## **Burlington Design Advisory Board**

### **DESIGN ADVISORY BOARD Tuesday, February 14, 2023 3:00 PM**

## MEMORANDUM

**To:** Design Advisory Board  
**From:** Scott Gustin & Garret King  
**Re:** 98 Sunset Cliff Road  
**Date:** February 14, 2023

SCALE: 1/4" = 1'-0"

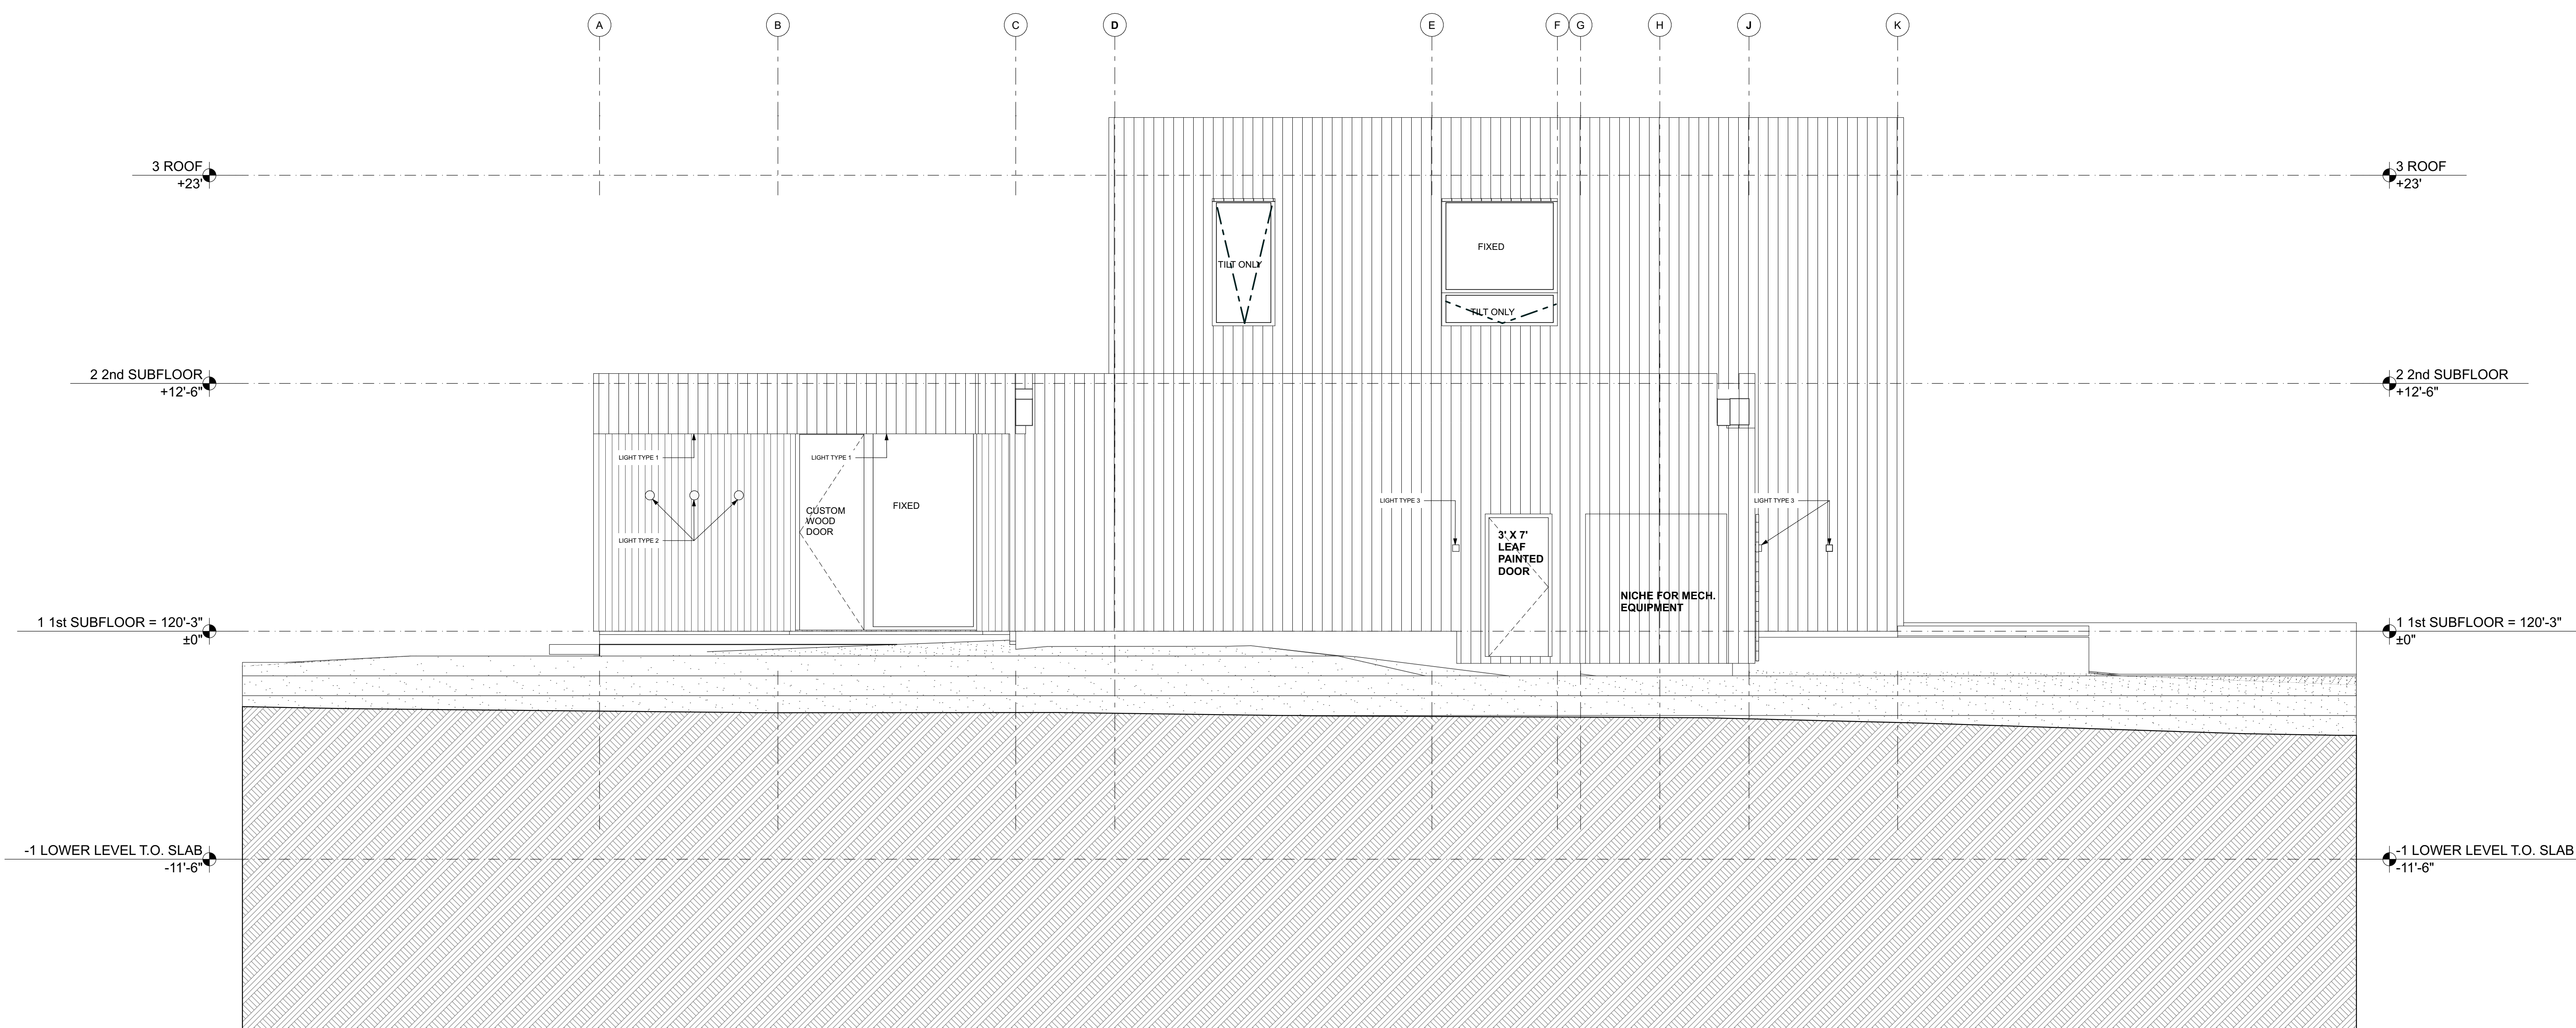
Outdoor lighting fixture specifications have been provided. Lighting locations are shown in the elevations drawings. Fixtures include: Type 1 (Recessed 700 lumen output), Type 2 (Decorative sconce 100 lumen output), Type 3 (Discreet wall sconce 701 lumen output). All proposed outdoor lighting fixtures utilize low output lamps and are acceptable for this residential installation.

The proposed home, along with its accessory porches, is similar in size and mass to the current home. The mass of the house will be defined by straight lines and square edges that clearly define the individual components of the house. It appears to have a symmetrical appearance when viewed from the front with two floors in the center and lower single stories extending off to the right and left sides. The proposed structure will be two stories just like the current building. The scale of the home is similar to nearby properties on the street including the additional attached porches. The reduced setback from the road is less than adjacent properties which pulls the new build away from the lakeshore. A perspective drawing should be provided.

The roof will be a dark colored flat membrane roof squared off with parapets matching the building siding that conceal the roof deck. This style is different from the more common hip and gable type roofs on the adjacent properties. The proposed roof design; however, is consistent and matches the modern style of the building.

The color and material for the new construction will mainly consist of dark charred wooden siding. The parapet extending above the flat roof deck will be clad in the same material. Accent siding for the covered entry and porch will be a stained wooden material. The aluminum clad wooden windows will be a black/dark color to match the siding of the house. The materials proposed are of acceptable quality and durability for this new construction.
